CIVIL CONSTRUCTION DRAWINGS  
FOR  
STEAMBOAT BASECAMP  
LOT 1 WORLDWEST SUBDIVISION  
1901 CURVE PLAZA, STEAMBOAT SPRINGS, CO 80487

Steamboat Basecamp - Phase I

REVIEW SET  
NOT FOR CONSTRUCTION  
8/5/21

SHEET: C.221

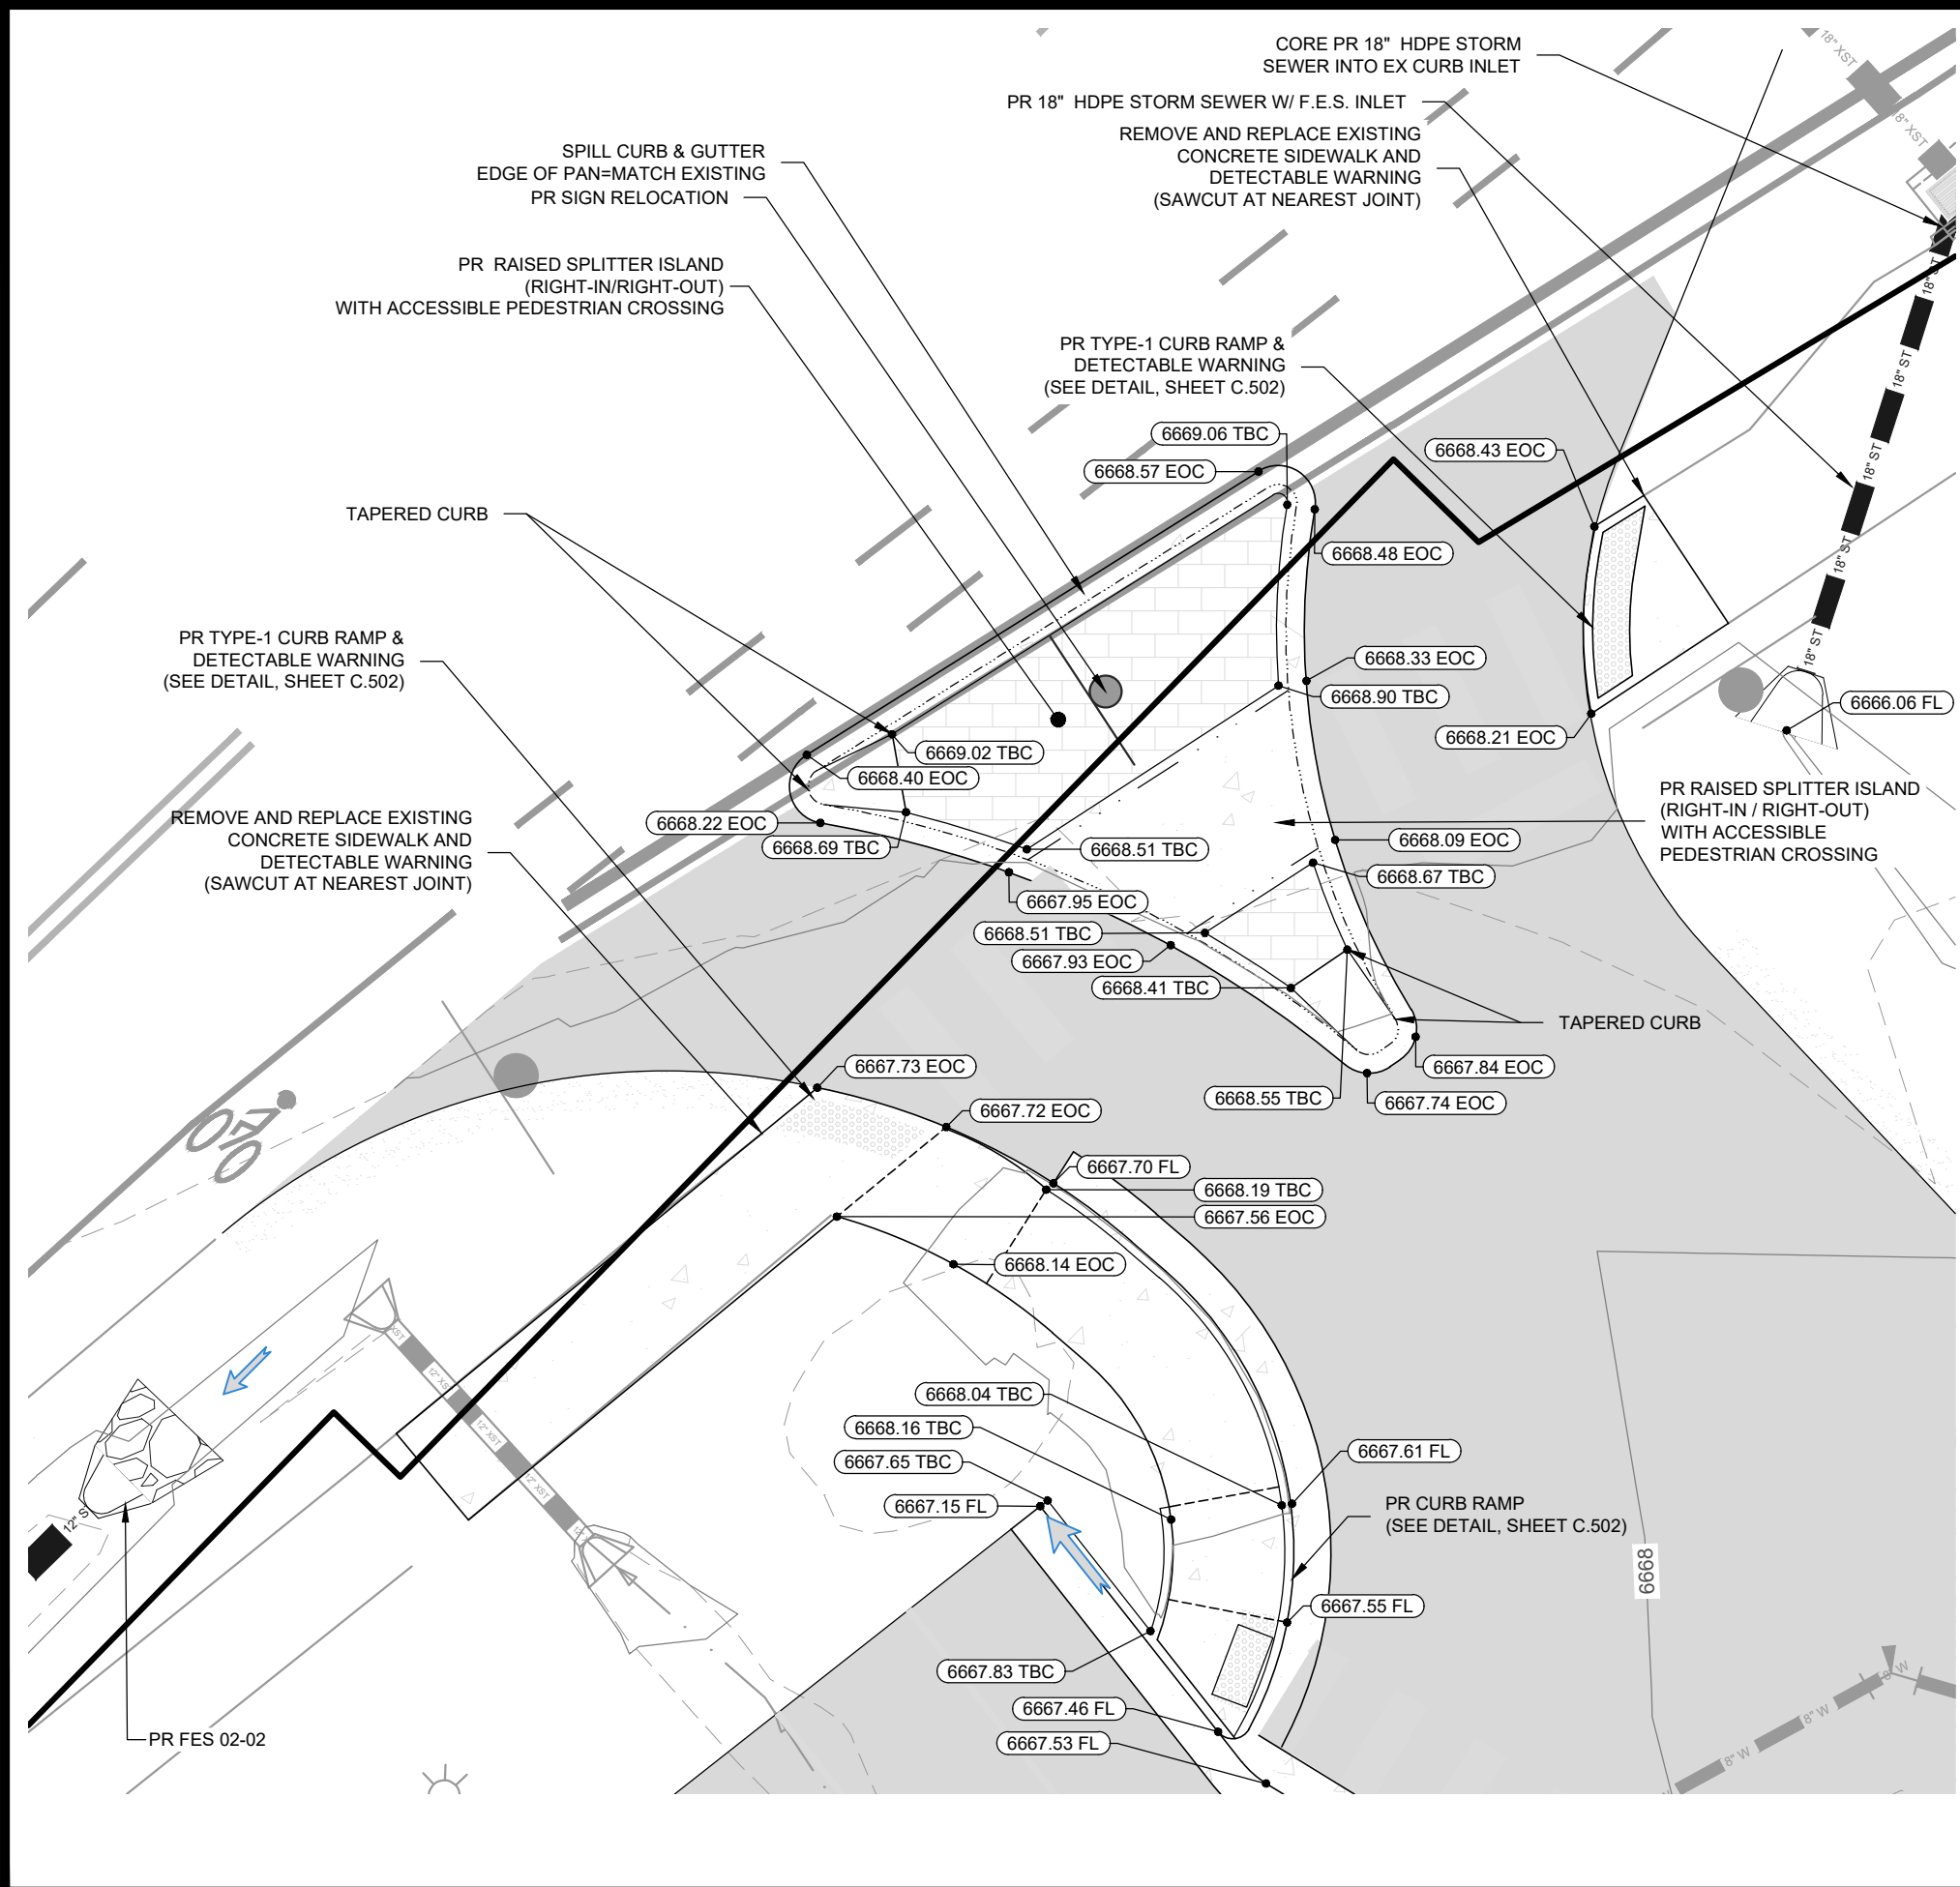
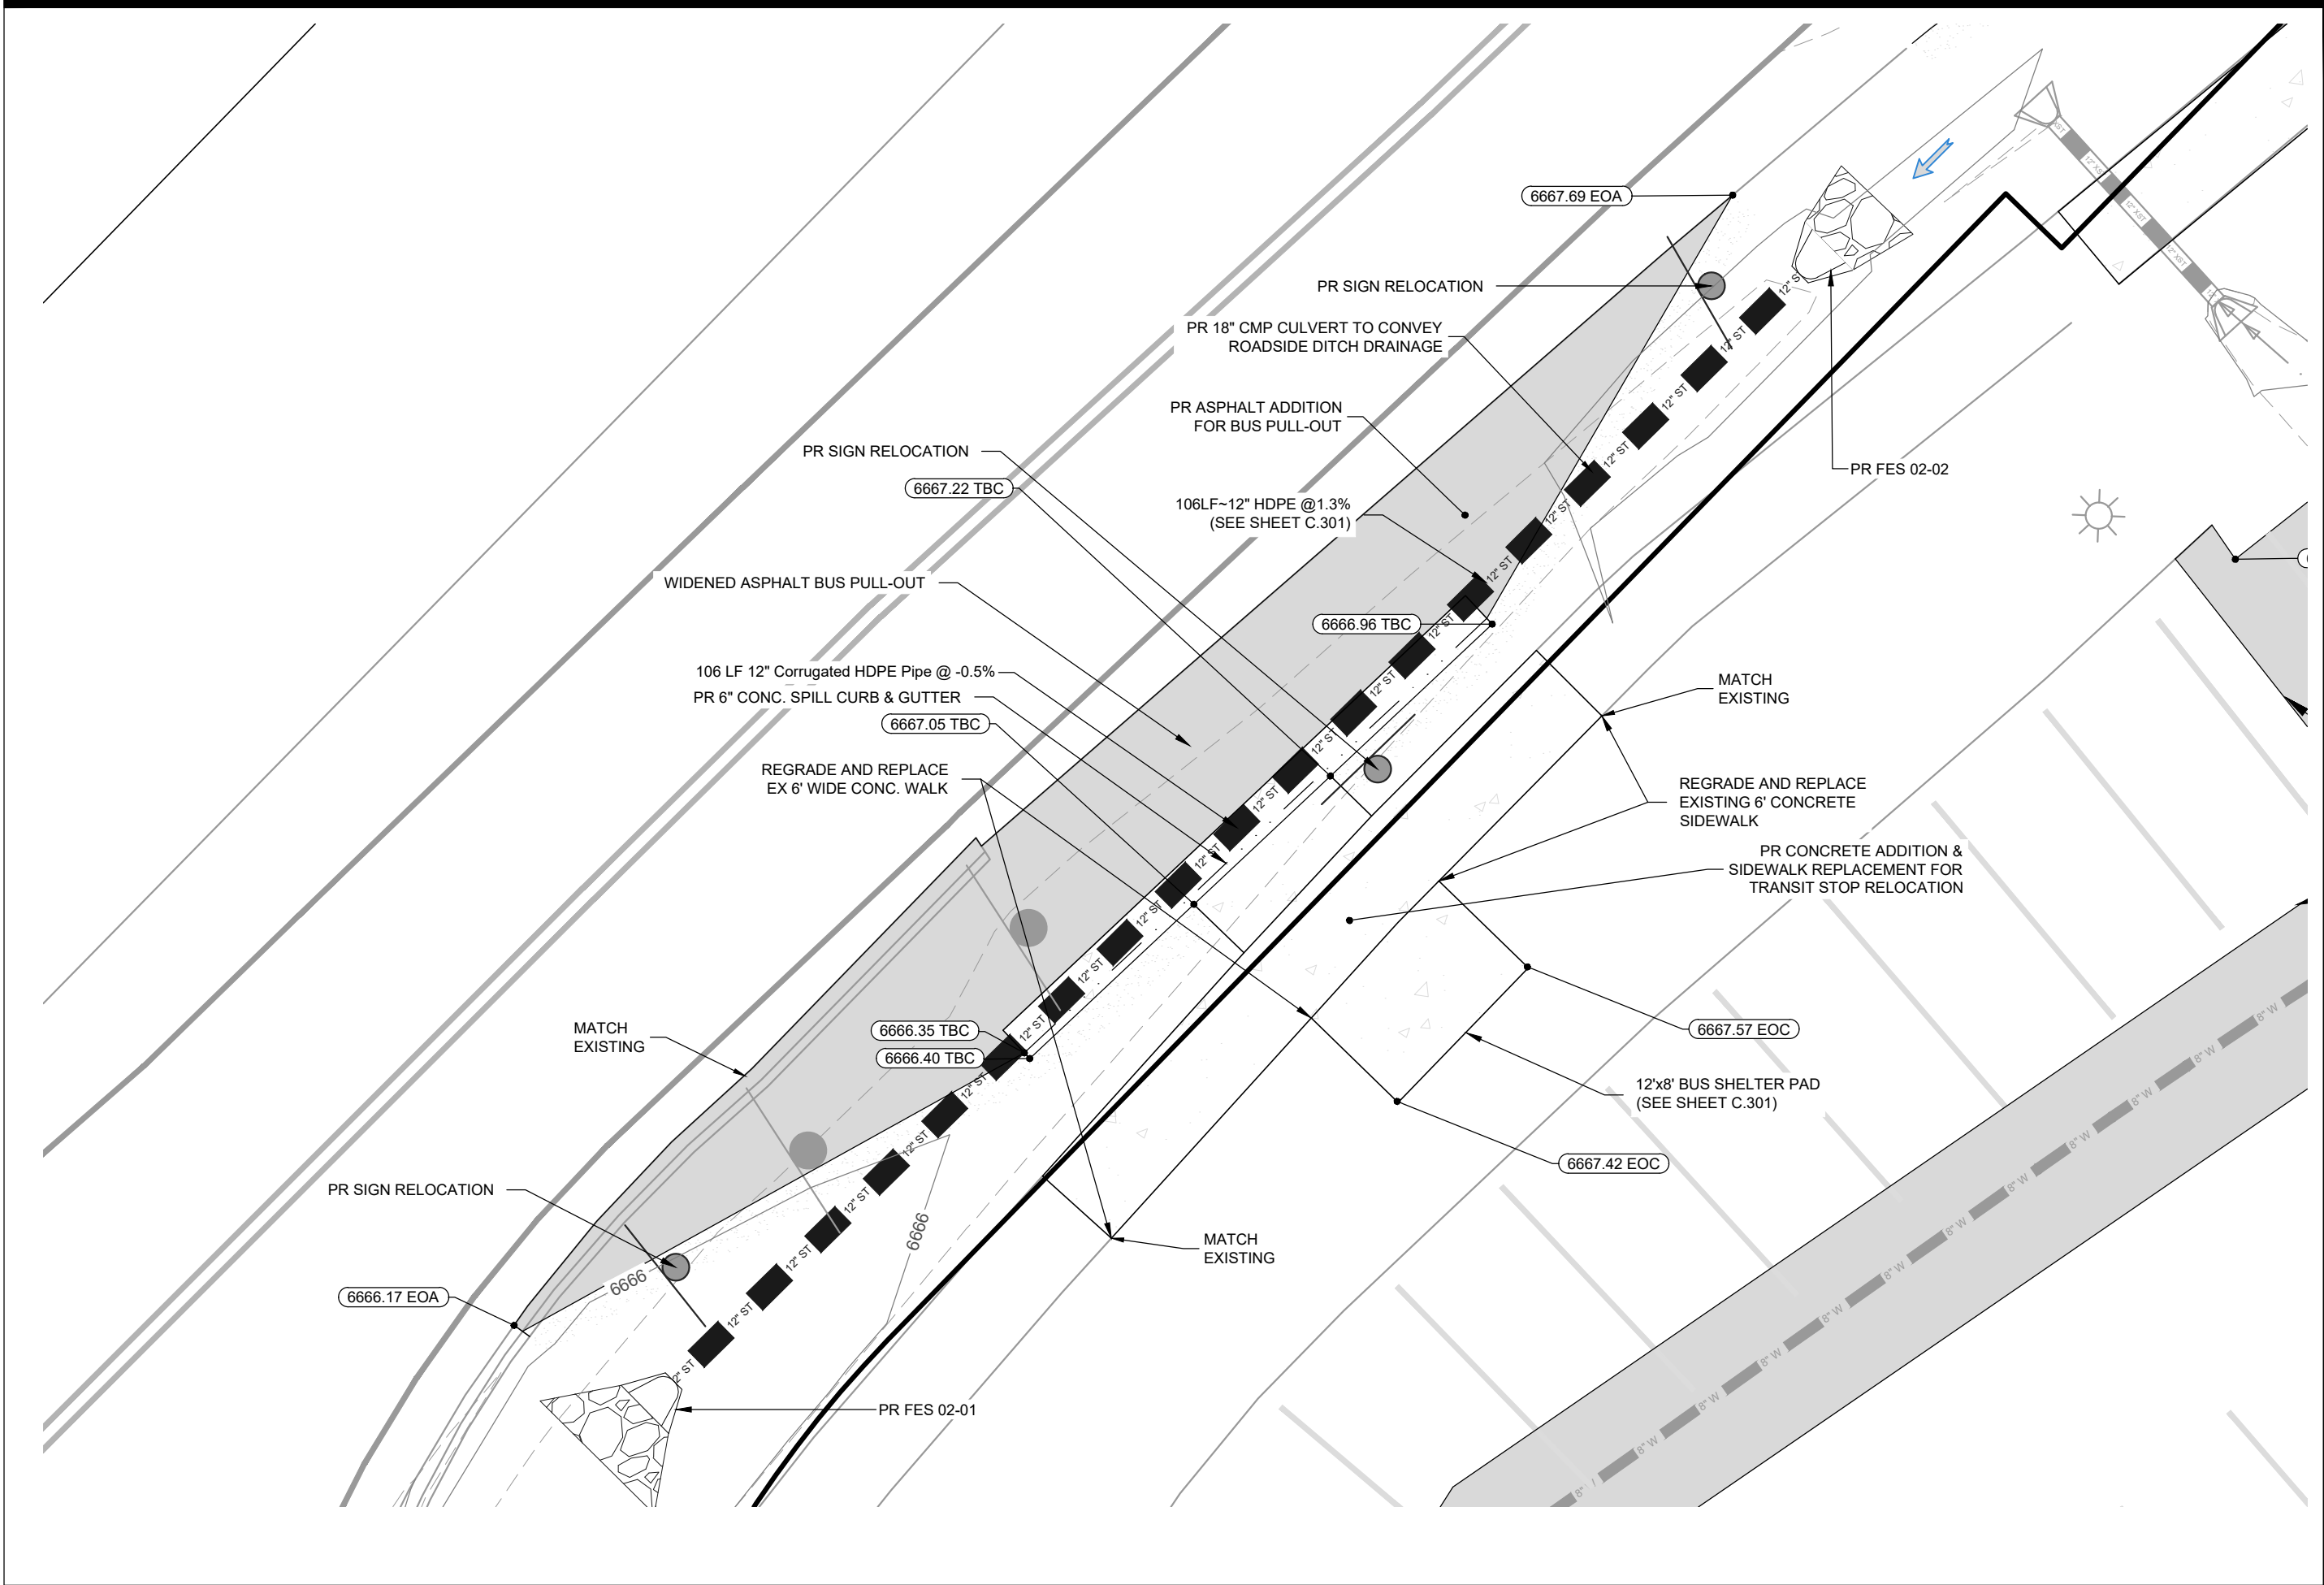
Remove this statement.  
The water and sanitary  
sewer mains have  
nothing to do with  
Basecamp per previous  
discussions. The  
acceptance will be  
associated with the  
future development in  
which the mains serve.
